**AMENDMENTS TO THE DRAWINGS:**

**REMARKS**

FIG. 3

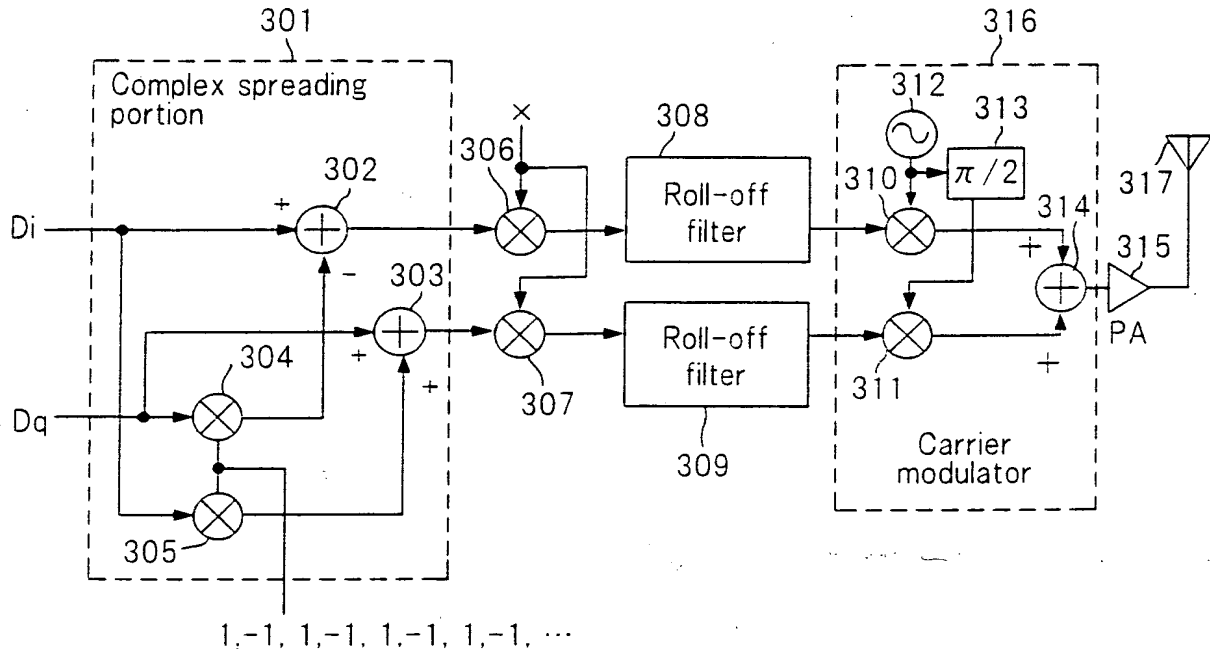
The reference numerals identifying the integrate and dump filters in Figure 3(b) have been changed to “398” and “399” to avoid duplicate use of the reference numerals 332 and 333. No new matter is added by these changes.

To correct multiple use of the reference numerals 332 and 333 in Figure 3(b), the reference numerals for the integrate and dump filters have been changed to 398 and 399. Corresponding changes have been made to the specification. A replacement drawing sheet and an annotated drawing sheet showing changes are included in the Appendix to this Amendment.
